Final Value Analysis Study Report

Davis Road Bridge Replacement

February 2017

Subject: Final VA Study Report (Task Order 238)
Davis Road Bridge Replacement Project

Figure 1. Regulatory Floodway at Davis Road

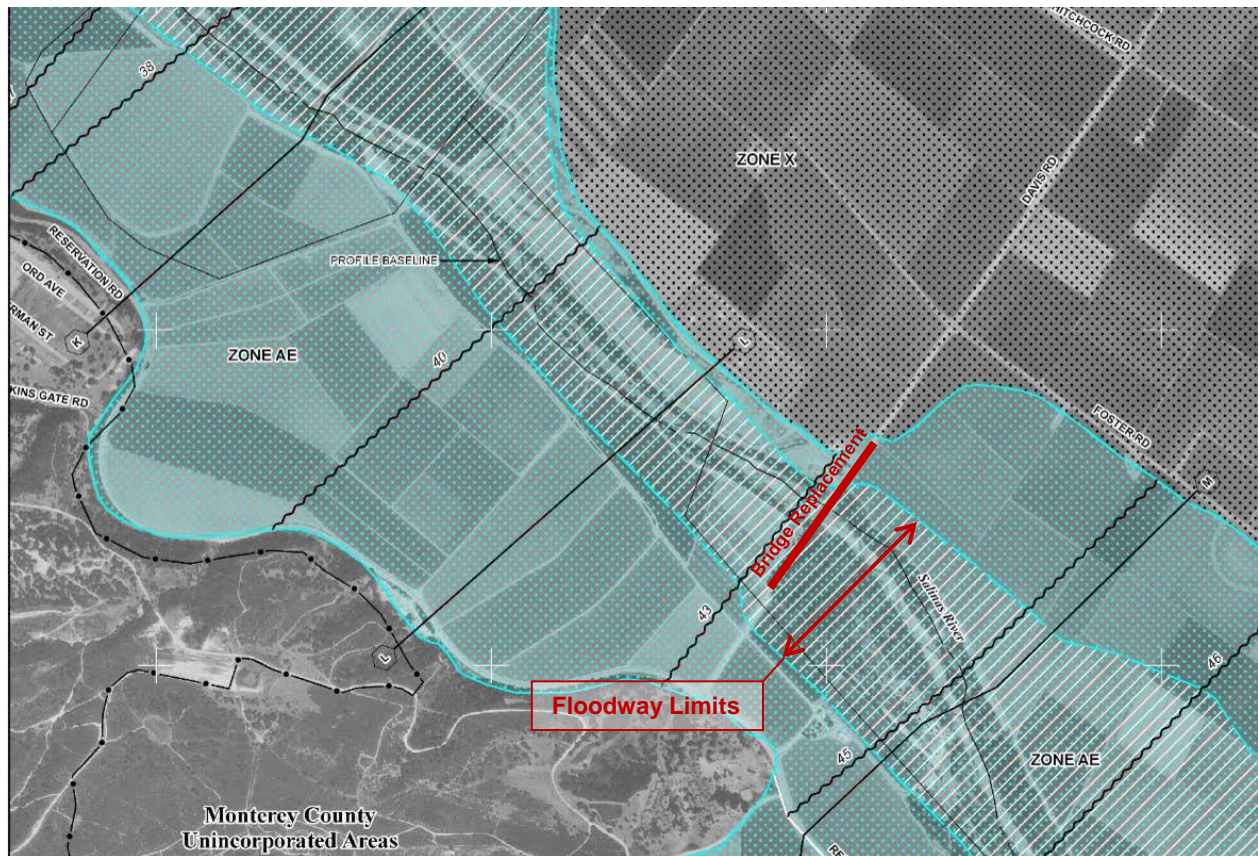
Construction of the bridge foundation, piers and superstructure will take place within a regulatory floodway as indicated in Figure 1. Federal regulations listed in CFR §60.3(d)(3)

Structural encroachment into the regulatory floodway necessitates completion of a “No Rise Certification.” The pertinent question is what constitutes “hydrologic and hydraulic analyses performed in accordance with standard engineering practice.”

Base flood elevations and the regulatory floodplain illustrated in Figure 1 were originally developed in 1980. A review of the Design Hydraulic Study Report indicates that the basis of hydrologic analysis for the Davis Road Bridge replacement is the original FIS hydrology developed in 1980, but the basis of hydraulic analysis is a set of topographic surveys completed circa 2008. Using the most recent topographic data available is consistent with standard engineering practice, particularly given the propensity for local topographic modification within the floodplain, permitted or otherwise. The use of the FEMA base flood discharge is also consistent with sound engineering practice as elaborated subsequently.

Figure 3. Revised 100-year Water Surface Profile near Davis Road

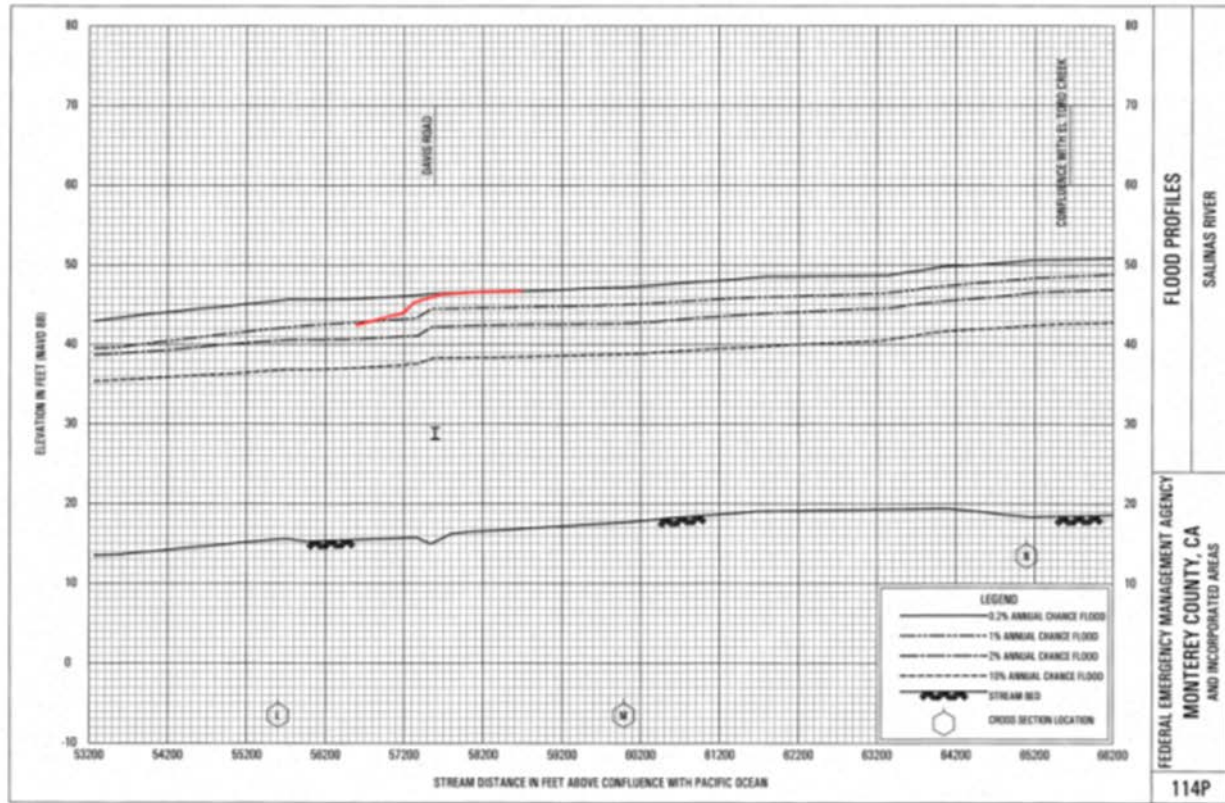
As evidenced by a comparison of water surface profiles, changed conditions in the vicinity of Davis Road have apparently increased 100-year flood elevations by up to nearly two feet, so the revised 100-year water surface elevation is equivalent to the previously mapped 500-year water surface. A non-regulatory levee constructed on the south bank west of the road may be at least partly responsible, particularly if said levee was built subsequent to 1980. This levee, which is roughly six feet higher than the adjacent protected ground, is located within the regulatory floodway and while it would be overtopped in the 100-year event, it represents a partial blockage of flow conveyance area on the south bank. When calculating water surface elevations upstream of Davis Road, the hydraulic effect of this levee cannot be ignored and the levee cannot be assumed to fail and completely wash out prior to the arrival of the peak flood discharge.

Potential hydraulic impacts due to bridge and road approach construction should be evaluated against the revised floodplain delineation rather than effective floodplain elevations.

Adopt Class IV bikeway cross-section and modify buffer between shoulder and two-way cycle track

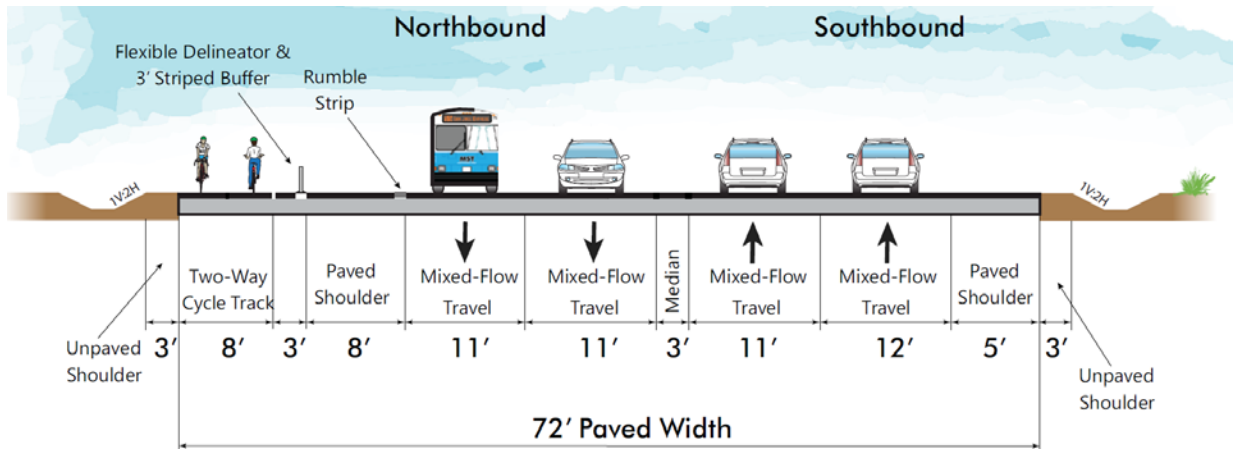
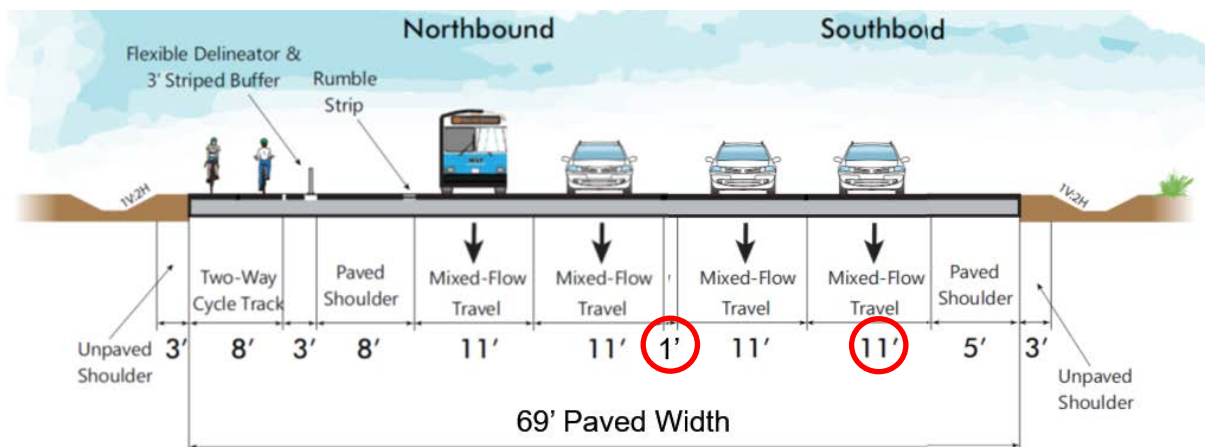
We further consider Alternative 5.2b to not be a viable alternative as discussed following. The V.A. Study Report Preview references a picture from the FHWA Separated Bike Lane Planning and Design Guide that uses parking stops to separate the cycle track from the travel way. See attached FIGURE 4 from VA Alternative 5.2b. It shows a 1' – 2' typical width of the parking stop measured from the buffer zone outside edge to the inside edge of the parking stop. It does not allow for a 1' wide buffer zone, nor does Figure 3.0 from Caltrans DIB 89. The Value Analysis Study Report also references pictures representing one way traffic in low speed environments. The minimum specified buffer zone is 2' for this situation with 3' recommended. Thus, we consider this scenario not applicable in our proposed high speed environment.

A cost was not calculated for V.A. Alternative 5.2b as again for our scenario that configuration violates the relevant design codes and guidelines regarding buffer widths and barrier types.

VA ALTERNATIVE 2.0

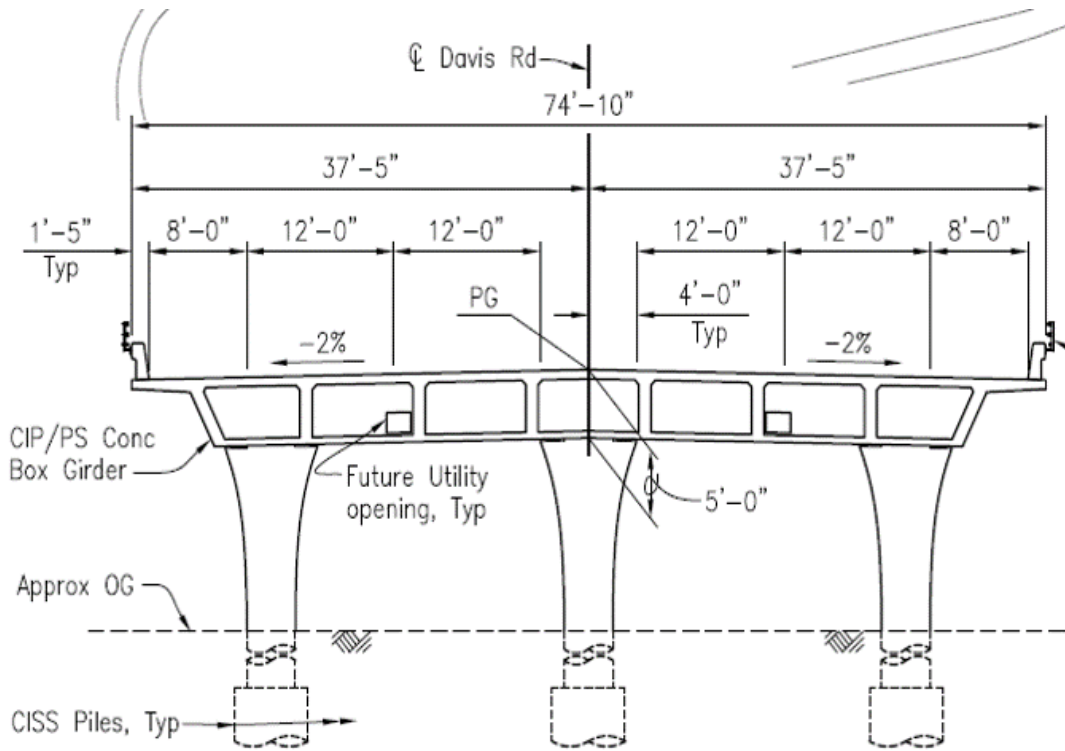
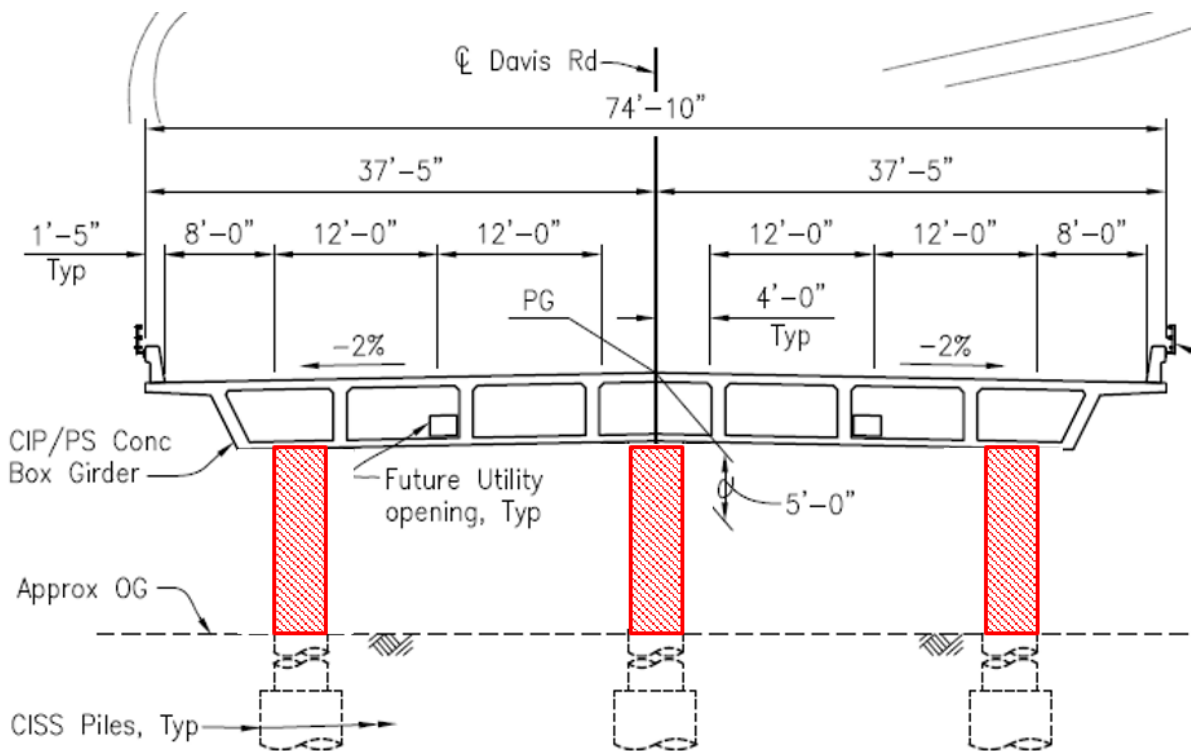
Eliminate column flares at bridge

Disposition:	Accepted
Validated Initial Cost Savings:	\$80,000 appears reasonable
Validated LCC Savings:	\$0
Project Development Support Cost Savings:	N/A
Validated Schedule Savings:	No change
Validated Change in Performance:	0%

Reconsider a precast girder bridge

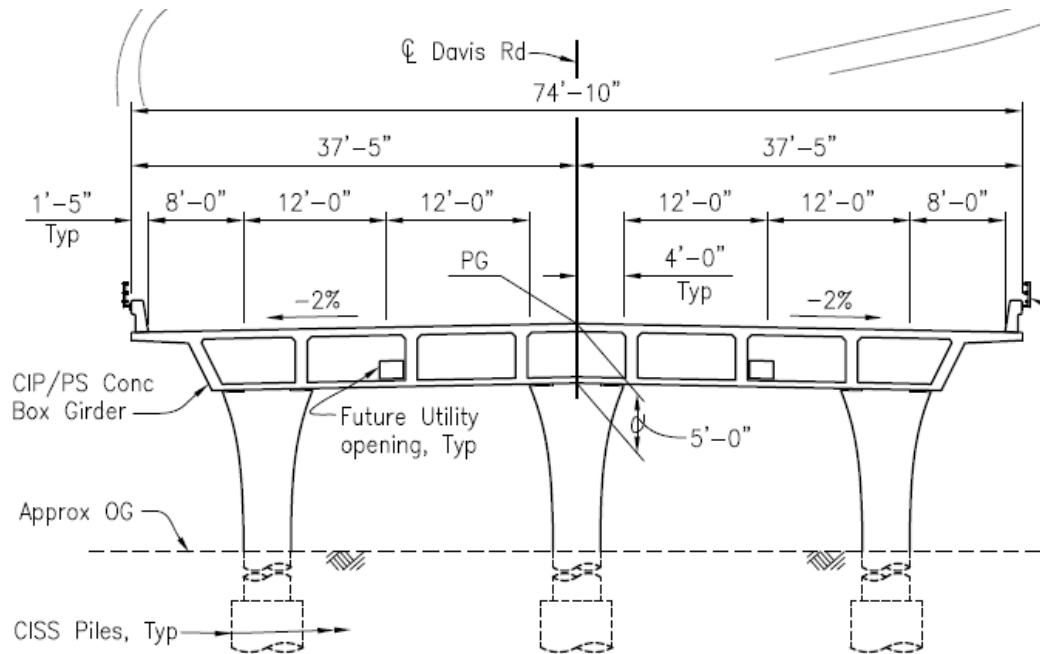
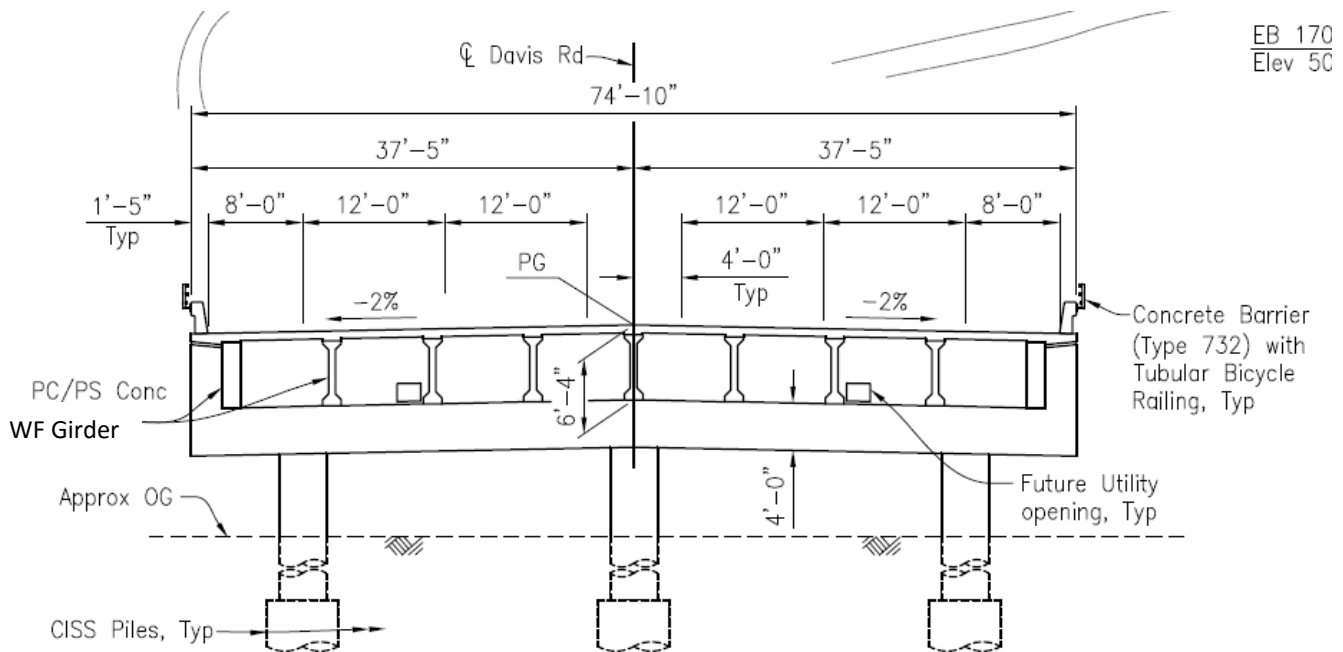
Assumptions and Calculations: The cost estimate assumes the same foundations and substructure (e.g. same foundation pile lengths).

Technical Feasibility: A preliminary superstructure will be designed using precast prestressed California Wide-Flange Girders to better predict quantities for this alternative. Prices of the precast girders will be updated using the latest available data from Caltrans and by contacting several precast suppliers. Other items will also be modified to reflect the new superstructure section.

A one-page addendum to the Type Selection Report will be prepared to summarize revisions to the report and confirm the recommended structure type. Included with this addendum is a revised General Plan Estimate and a comparison of construction schedules for the two proposed structure types.

Replace first 3 spans at each end of bridge with flat slab deck on precast pile bents

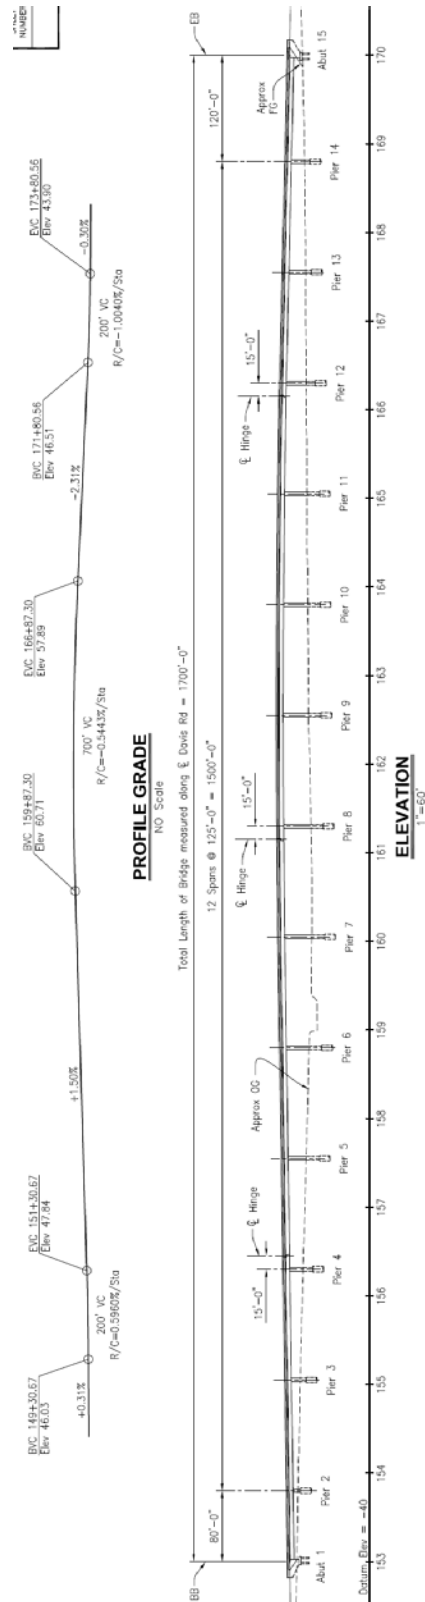
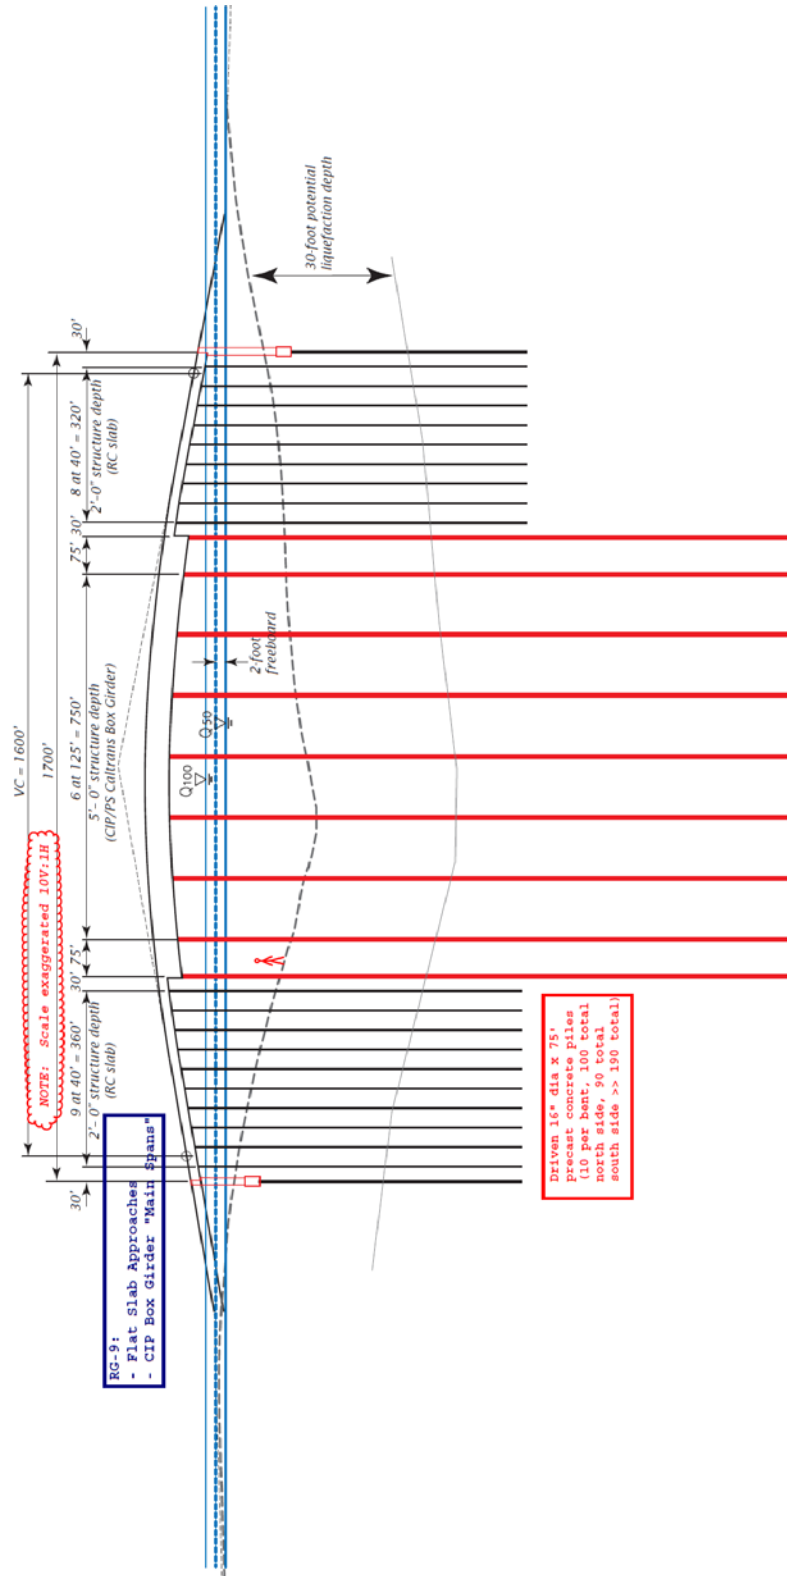
Replace first 3 spans at each end of bridge with flat slab deck on precast pile bents

Disposition:	Rejected
Validated Initial Cost Savings:	N/A
Validated LCC Savings:	N/A
Project Development Support Cost Savings:	N/A
Validated Schedule Savings:	N/A
Validated Change in Performance:	N/A

The soil borings completed in 2009 indicate liquefaction potential due to loose sandy soils encountered at the site. The liquefiable soil layers of up to 30 feet thick were identified. For estimating the design acceleration response spectrum (ARS), both liquefied and non-liquefied states need to be evaluated.

For liquefied case, the site is not consistent with the basic assumption of Caltrans ARS Online tool ($V_s \geq 150$ m/s). Per Appendix B - Figure B.12 of Caltrans Seismic Design Criteria (SDC) v1.7, the site is classified as a "Site Class F" site which is defined as "Soils vulnerable to failure or collapse under seismic loading" and a site-specific seismic evaluation is required for "Site Class F" sites.
